Borough of Rumson

APPLICATION TO THE ZONING BOARD OF ADJUSTMENT

Denial Memorandum

Memorandum – Statement of Variances Review

DATE	11/30/25
DRAWN BY	JM
SHEET NO.	V-2

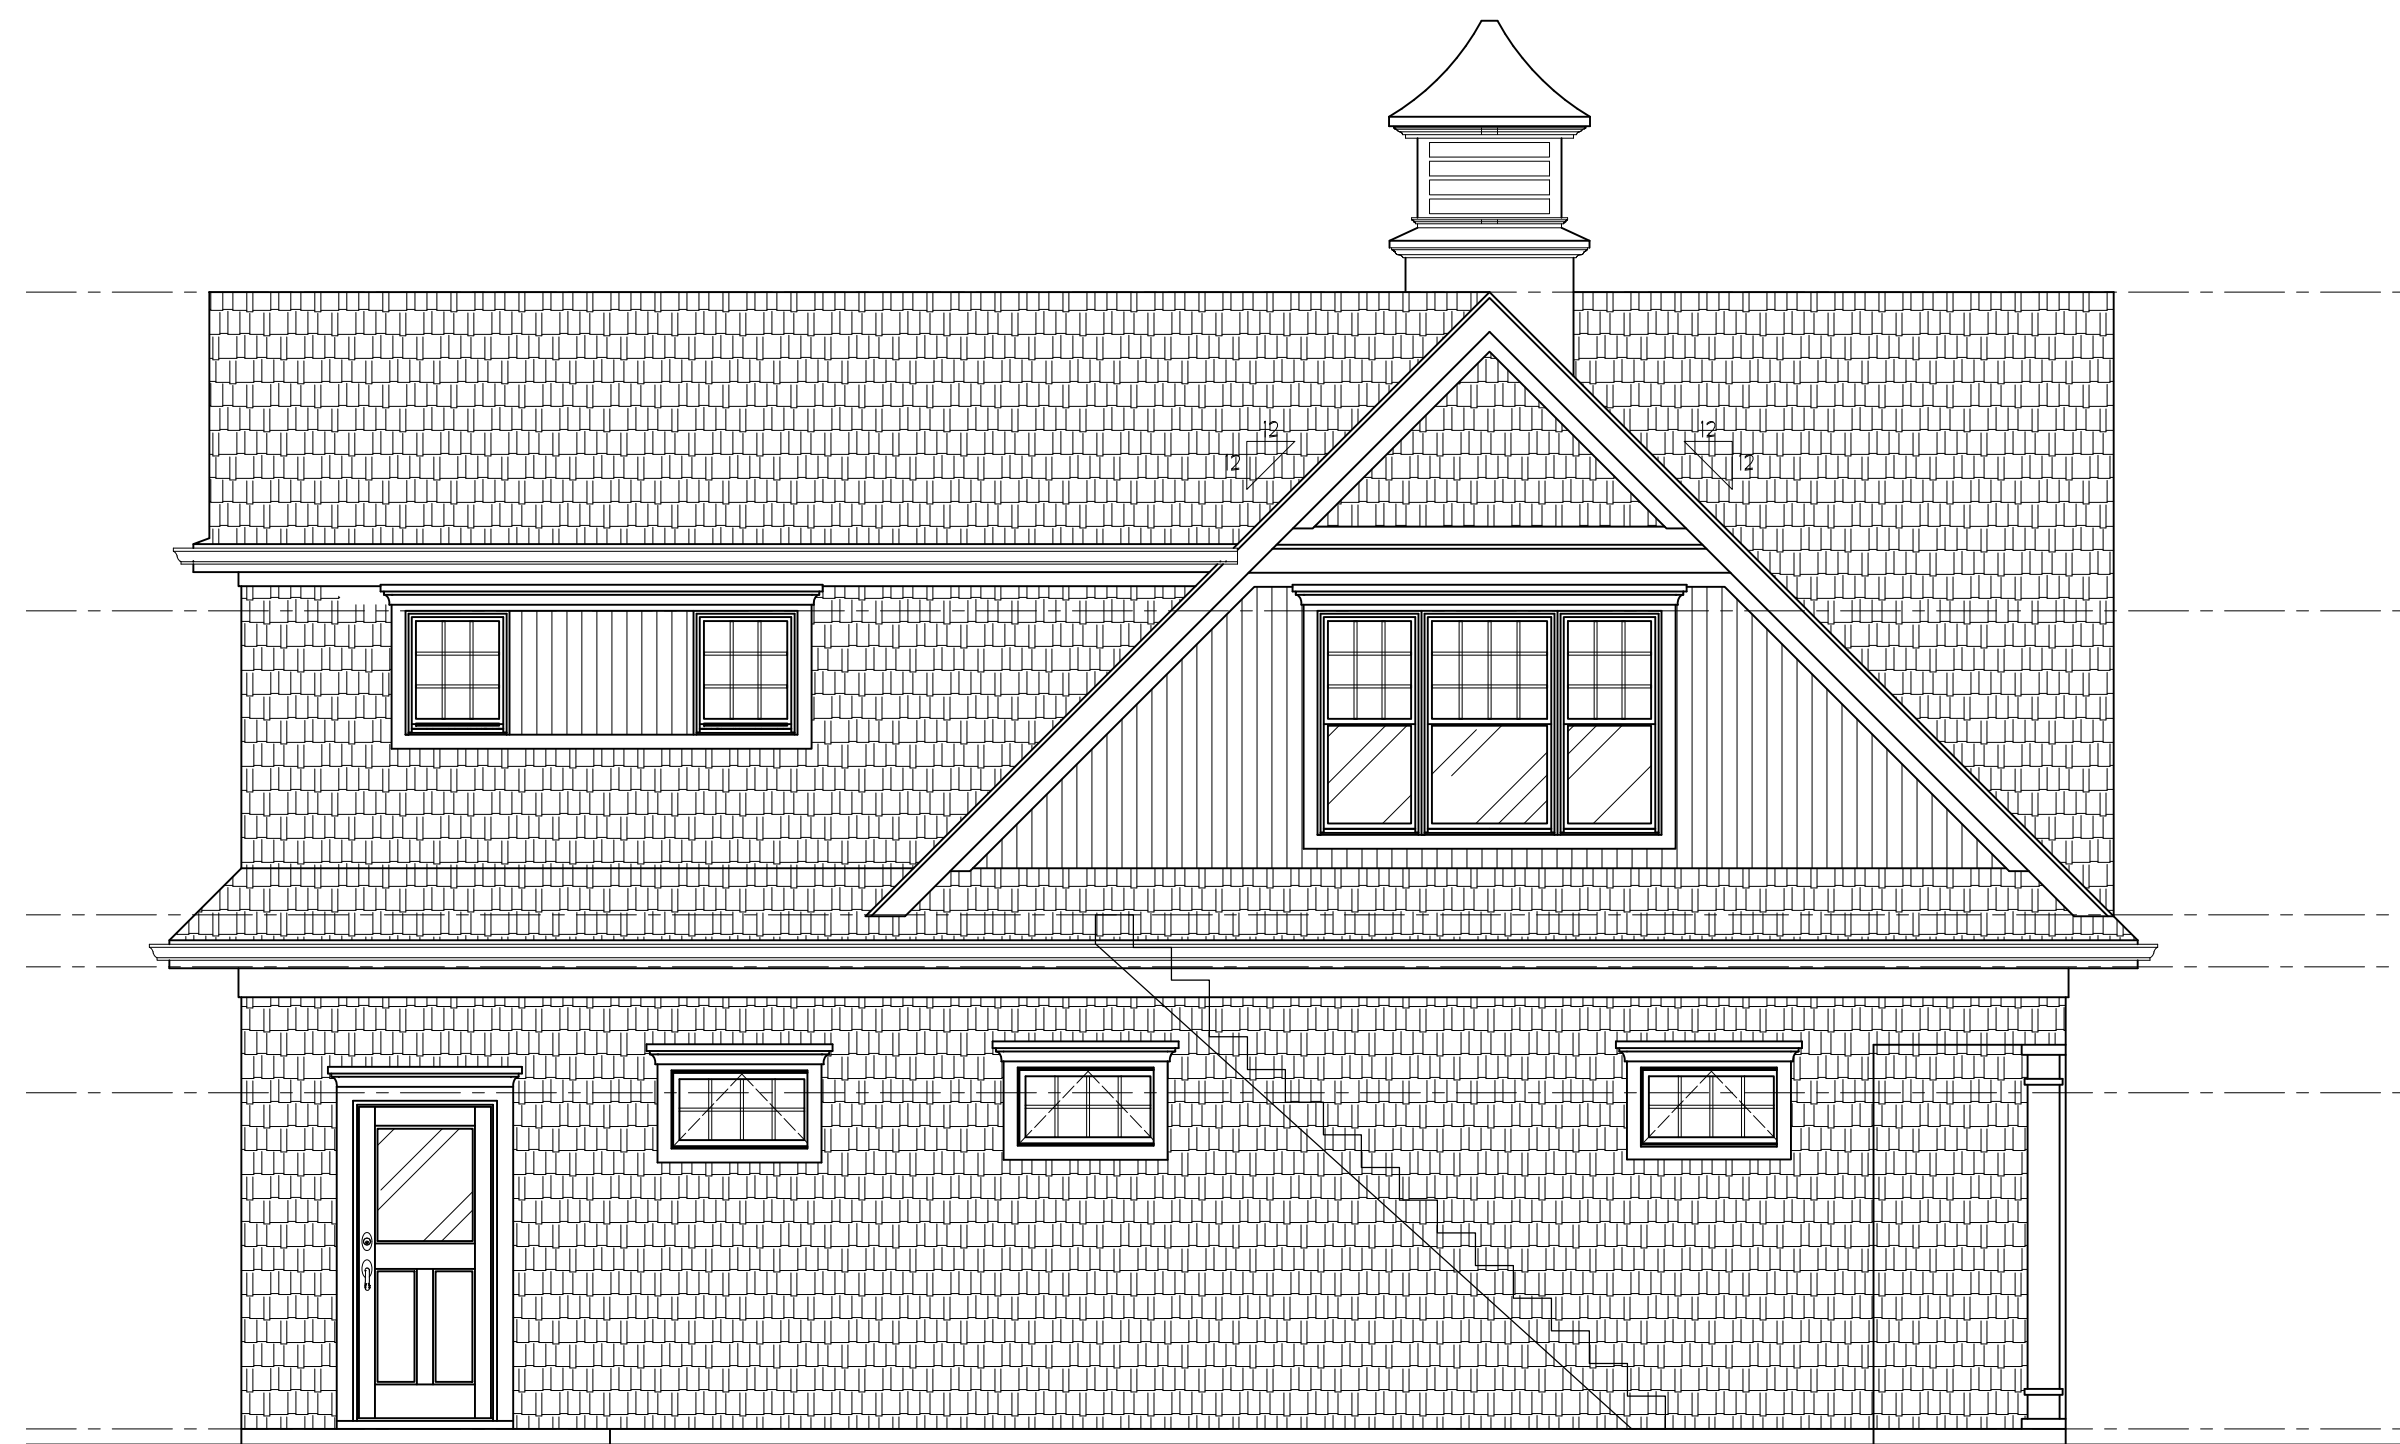
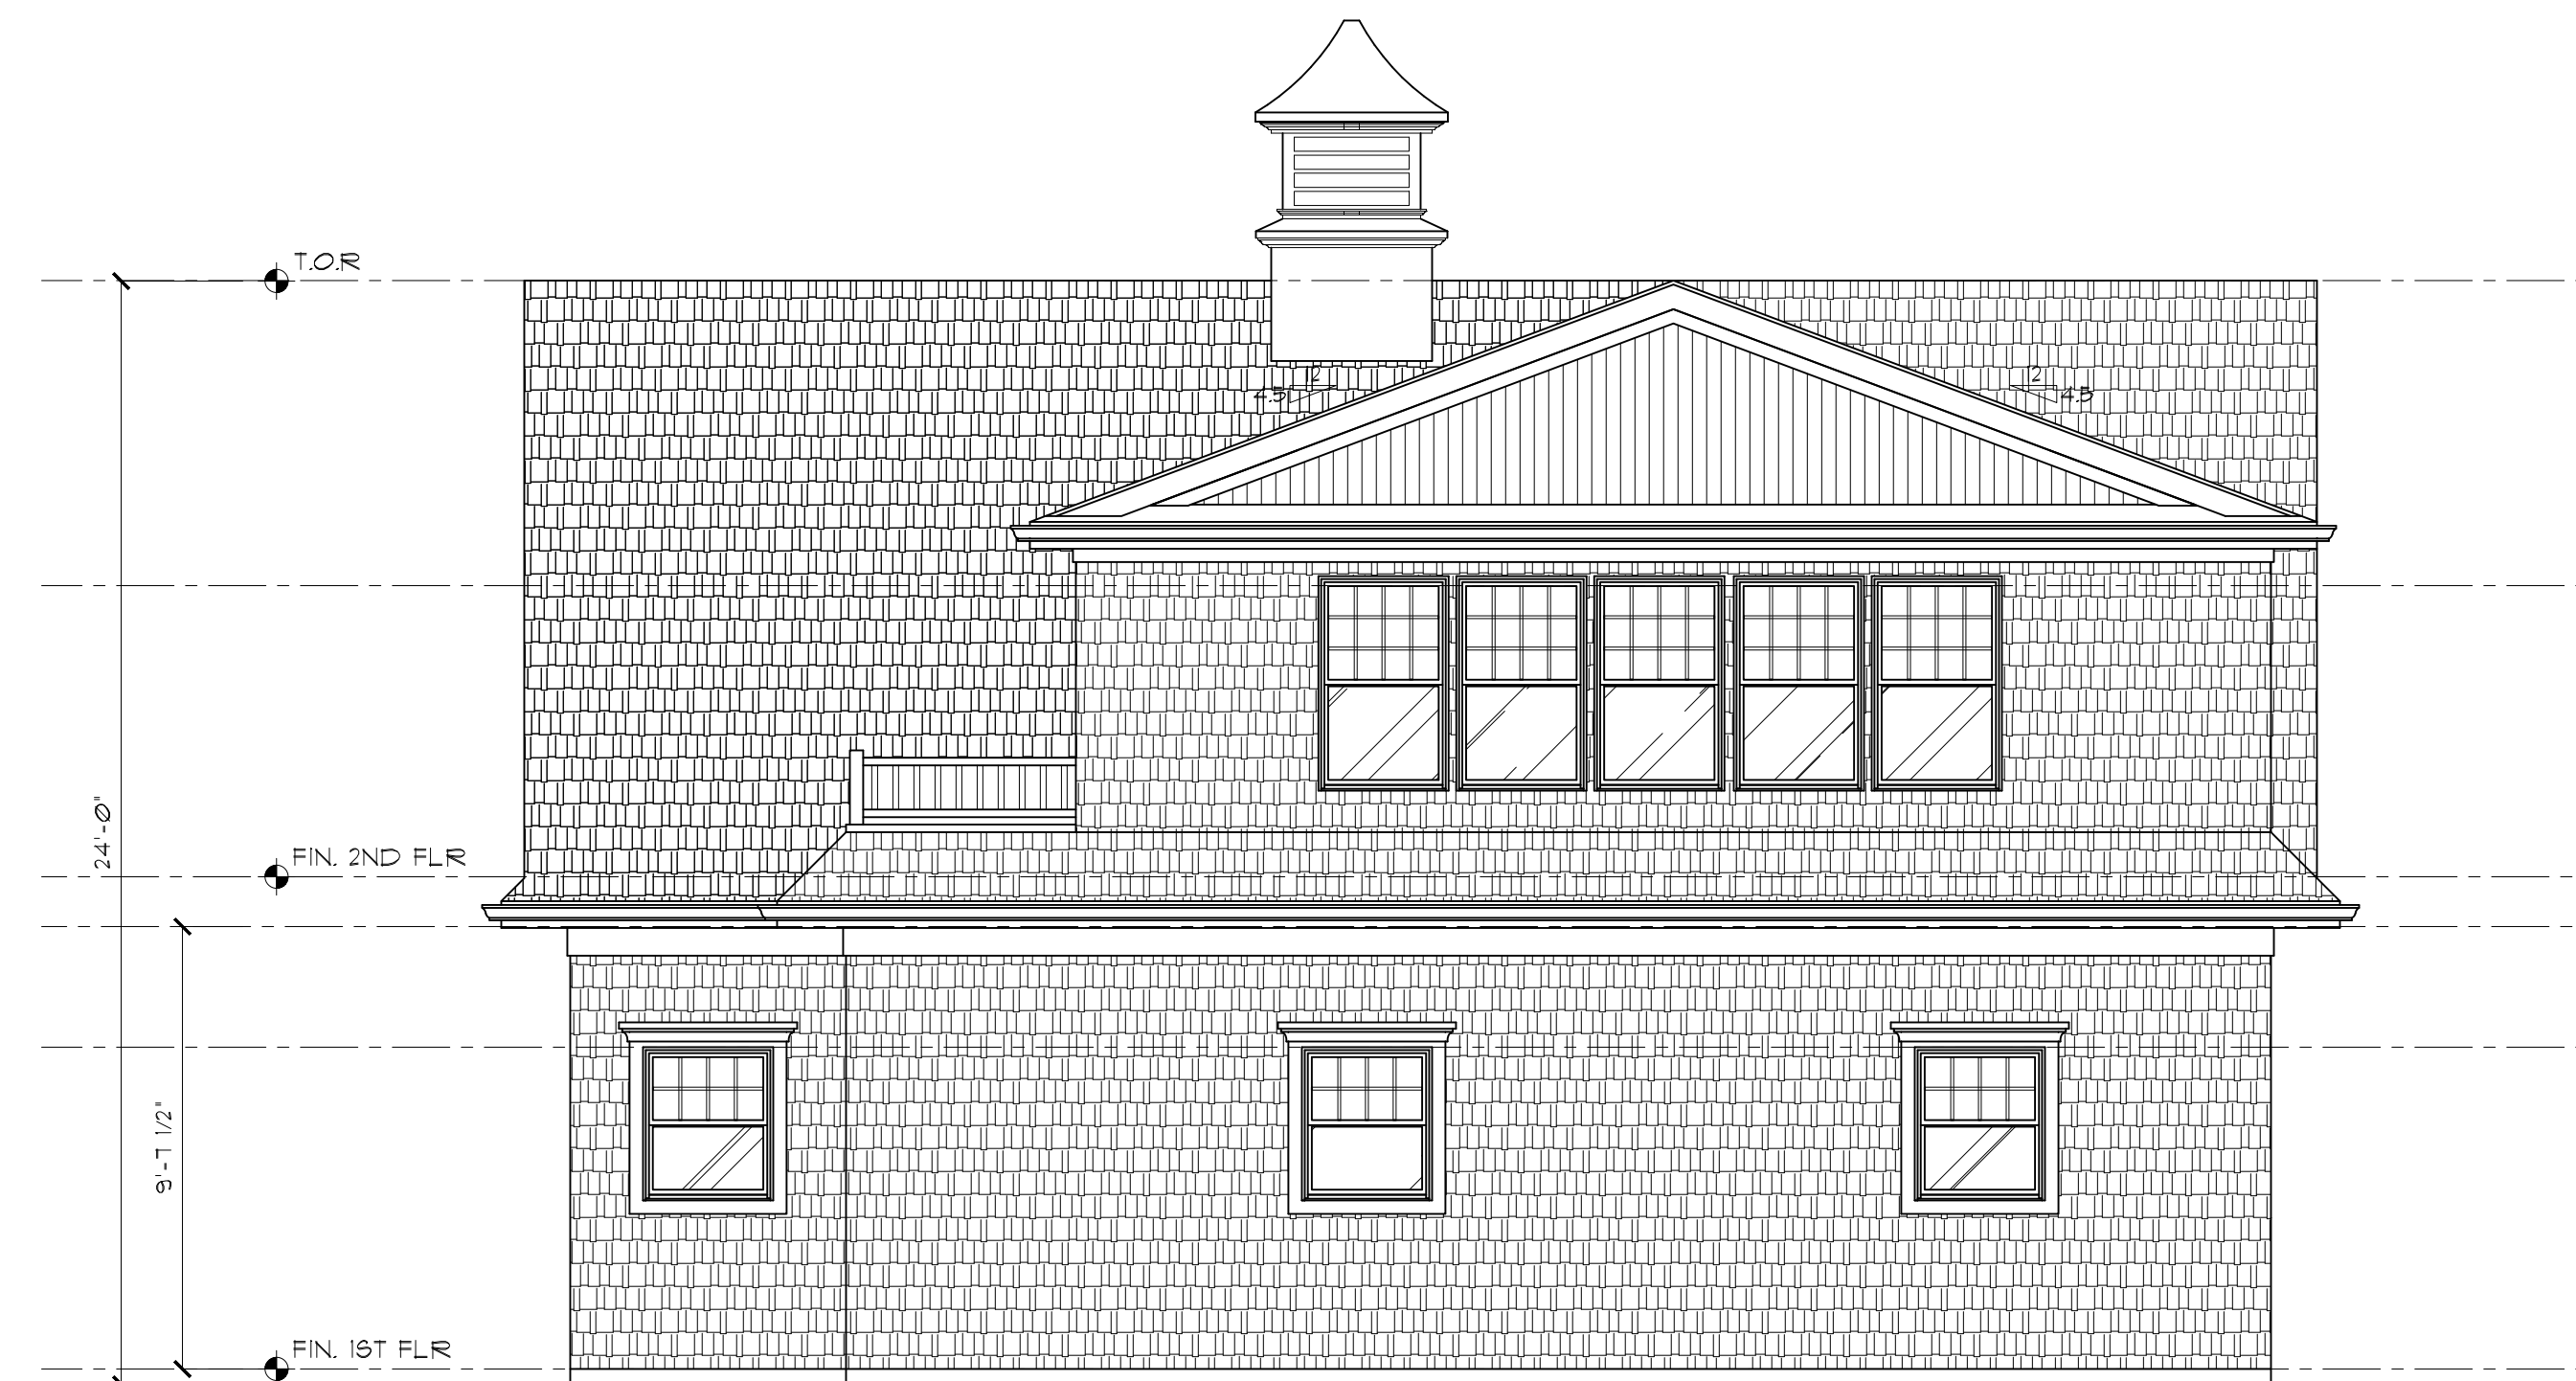
- (Sched 5-2) The proposed building height of 23.67' is measured from an elevated grading, approximately 3' higher than the original grade. The corrected building height is approximately 26.67, whereas accessory buildings may not exceed 24'.
- (Sched 5-4) Maximum Building and Lot Coverage exceeded.
- The proposed elevated grading plan requires approval from the Borough Engineer.
